# Environmental Review Team Report

## The Ridings Vernon, Connecticut

May 1979

ENVIRONMENTAL REVIEW TEAM REPORT  
ON  
THE RIDINGS SUBDIVISION  
VERNON, CONNECTICUT

# Preliminary Subdivision Plan

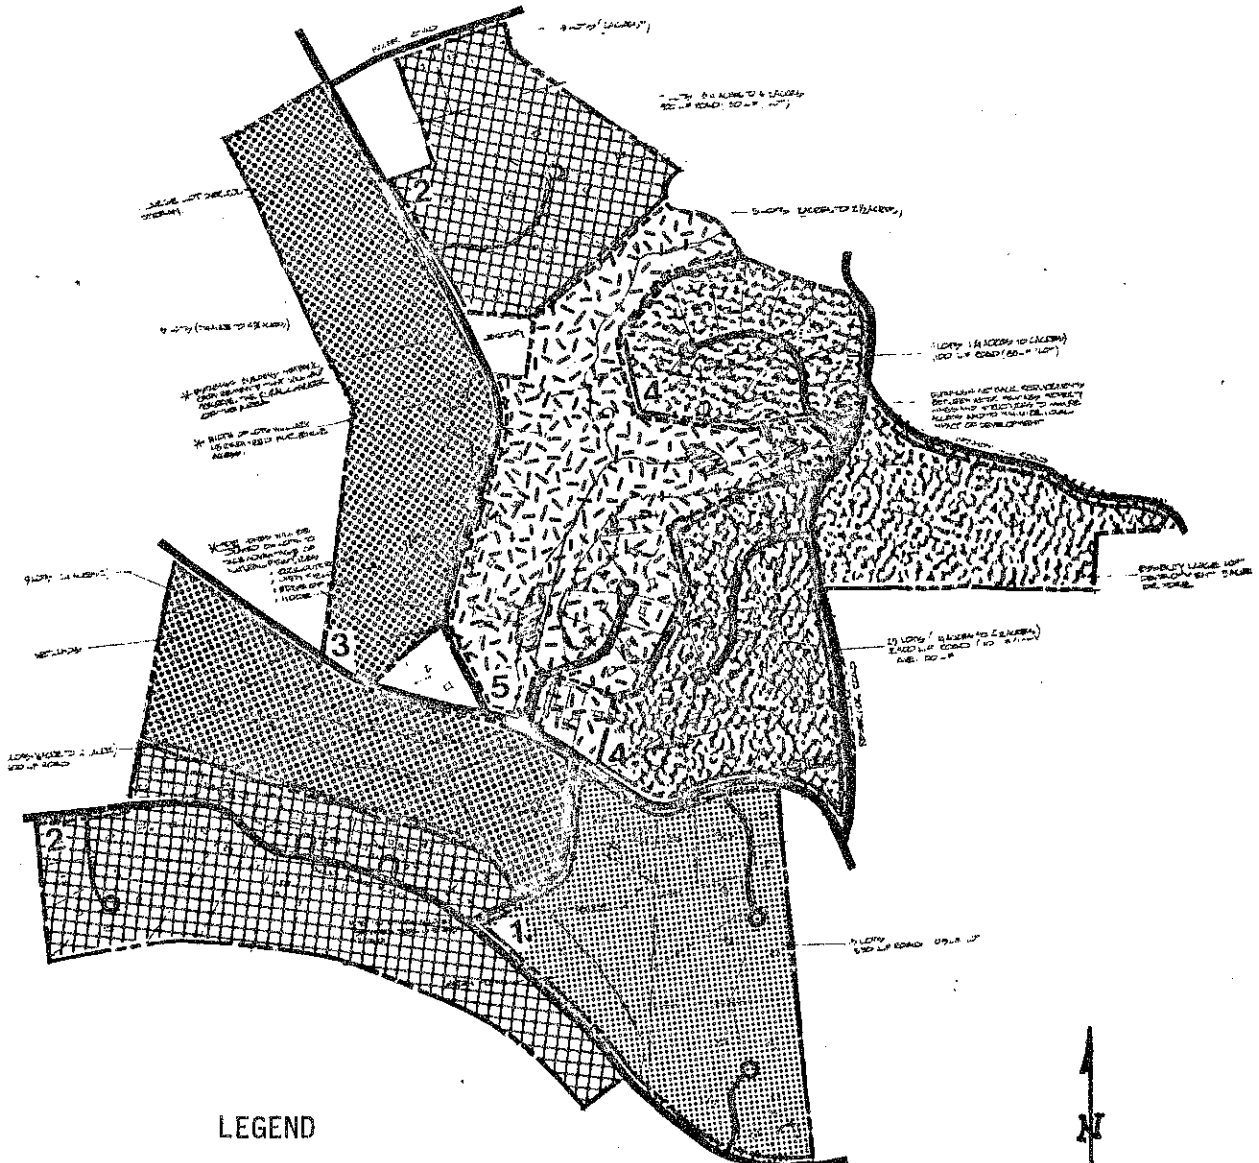
Preliminary plans show the development of 120 to 150 lots of 1 1/2 to 7 acres in size. These lots would be served by on-site wells and on-site septic disposal systems. The majority of these lots would be used for single family residences; however, several cluster town houses are planned for the Valley Falls Road area. Approximately 125 acres will be reserved as open space, to be maintained by a homeowners association. Tennis courts and a riding stable are also planned for this area. Pre-review discussion with the developers indicated that they intend to build the inner road system first and sell off lots to individuals. The buyer would decide, at his discretion, when and how he would develop his lot. Development of the property will occur in five phased sections as shown on the preliminary plan.

Installation of septic systems may be difficult in some areas of this development due to soil conditions. Percolation tests should be conducted in the area of sewage disposal systems on each proposed lot. Appropriate soil testing of Phase 3, 4, and 5 lots should be conducted prior to submission of these Phases for Planning

Protection of trout streams should also be a major concern. Dwelling establishment in certain portions of Sections 1 and 3 may cause problems with oxygen levels in the streams.

Although the developer apparently recognizes the value of the streams in planning to avoid problems near them in Phases 4, 5, and the northern portion of Phase 2, and in leaving most of the stream-belt as open space, problems may occur if Phase 1, 3, and the southern portion of Phase 2 go ahead as planned.

It was observed from the preliminary plan that some house lots may be located in areas that are too wet for septic systems. Concern must be given to each individual house lot for proper location of the system. The scale used to make the initial soil survey was not intended to delineate small wet areas that may cause considerable problems in areas as small as a house lot. For this particular use, more detailed on-site investigations are required. The investigations made on April 19th confirmed the need for individual lot inspections before final plans are approved.

**Floodprone Area**

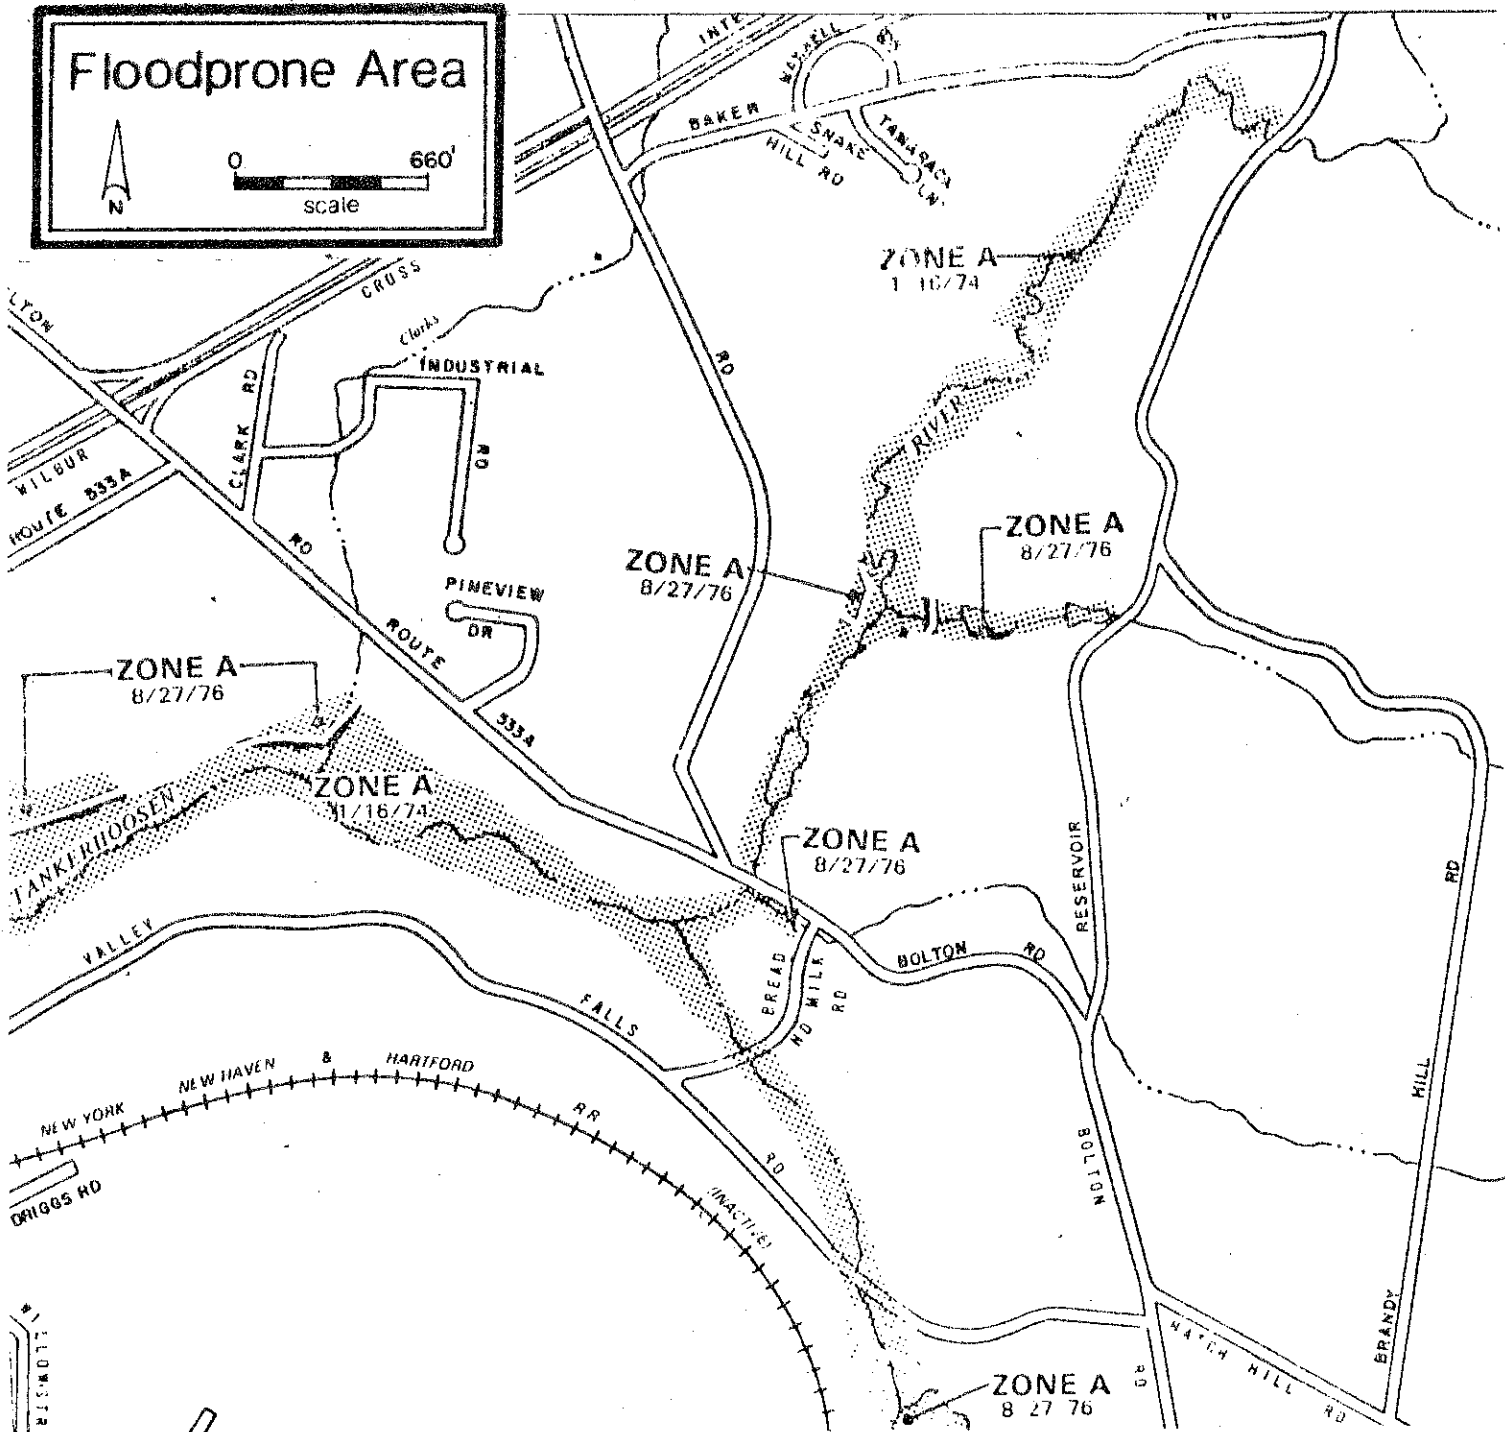
Part of the section of the site between Valley Falls Road and Bolton Road is presently subject to inundation by the statistical 100-year flood. A portion of a 1974 HUD study outlining this special flood-hazard area is included.

# TEST HOLE LOCATIONS

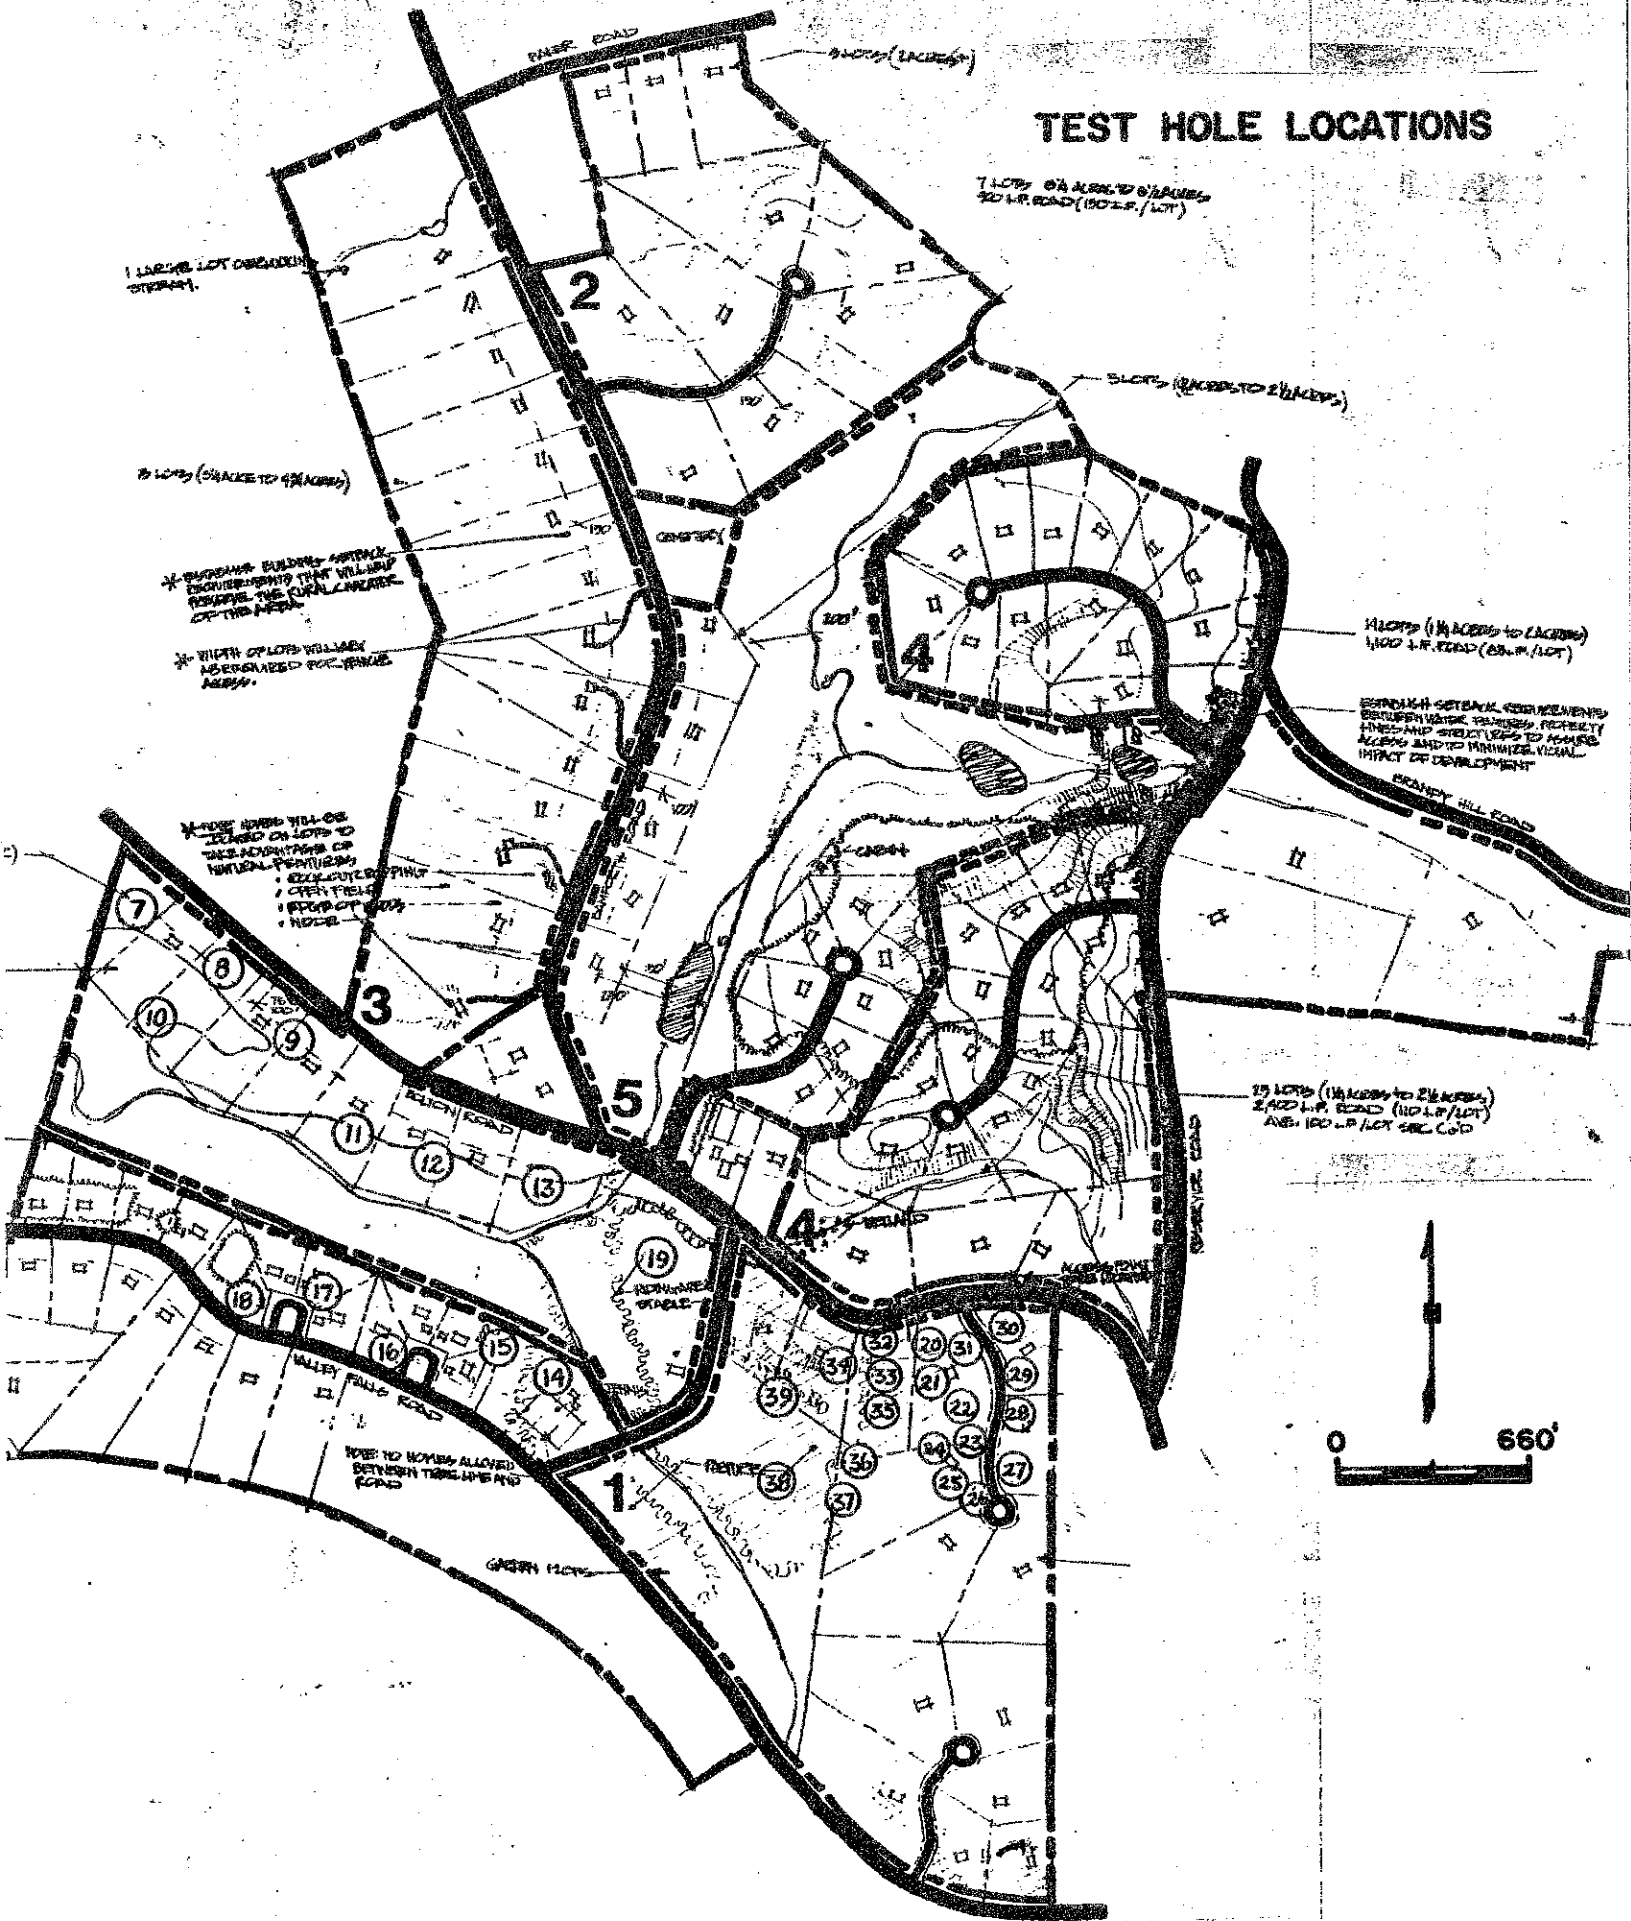
The following comments were submitted by the Team Sanitarian from the State Department of Health. They are in reference to the 39 deep observation pits located on Phase I of the preliminary plans. Test results and soil observations were submitted by Gardner and Peterson Associates, engineers for the developer.

Test holes numbers 17 and 18 located north of Valley Falls Road and west of the stream which crosses Valley Falls Road flowing in a northerly direction, were found to have extremely high water table conditions. The area had little or no slope. This area would not be acceptable for subsurface sewage disposal.

Test hole number 16, located north of Valley Falls Road and east of the aforementioned stream, exhibited soil characteristics which would place no extraordinary constraints on subsurface sewage disposal. A five foot deep stand pipe was dry to 60 inches below grade on April 19. However, the area of this soil was limited and extremely wet conditions were observed as one proceeded further north from Valley Falls Road. This wet area coincides with that mapped as alluvial by the Soil Conservation Service (Inland Wetland - subject to flooding).

Test holes numbers 7, 8, 9, 10, 11, and 12 exhibited soils which may be expected to have rapid percolation rates. Stand pipes at test holes 9 and 10 had water at 46 and 42 inches below grade on April 19. Seepage was recorded at depths of 44, 58, and 60 inches in test holes 7, 8, and 11, respectively, during the original testing. No groundwater was observed in test hole #12. Little slope was present on any of these proposed lots.

Based on these tests, subsurface sewage disposal would appear to be feasible in these general areas. Engineering design would be necessary in order to assure proper separation distances from the bottom of leaching areas to maximum high ground water levels by proper system design in regard to invert elevations of house sewers, septic tank inlets and outlets, and distribution pipes. The Public Health Code requires a minimum separation distance of 18 inches between the bottom of leaching areas and maximum ground water elevations.

# AREAS WITH POSSIBLE LINE-OF-SIGHT PROBLEMS

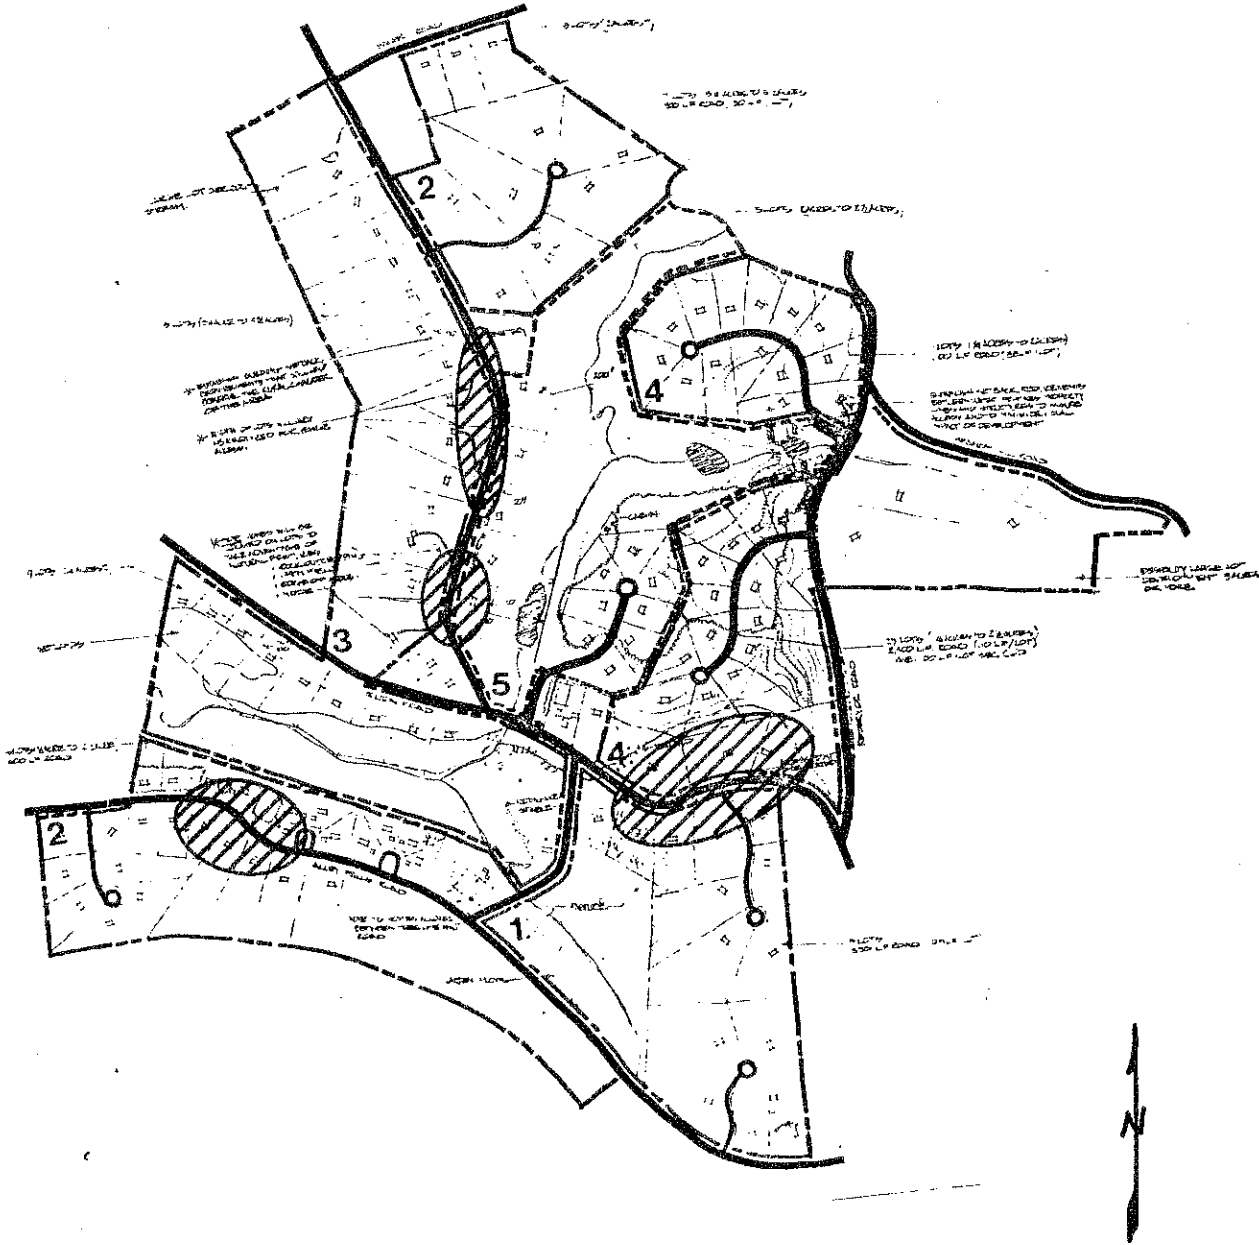
A major concern for the Vernon Planning and Zoning Commission are the number of driveways which will be entering these established town roads. A potential of 19 lots would enter onto Bamforth Road, 16 lots may enter Bolton Road and 15 lots would enter Valley Falls Roads. Due to the curving nature of certain parts of

these roads, blind driveways may be a common occurrence. It is the Team's recommendation that in danger spots such as those noted, lots be reoriented to have access onto cul-de-sacs. Another alternative on Bamforth Road in particular, would be the establishment of additional townhouse clusters served by small loop roads or a reorientation of lots to several cul-de-sacs extending from the existing road. These methods would reduce the excessive number of entrances onto Bamforth Road and eliminate some of the line-of-sight problems which would exist with the proposed plan.
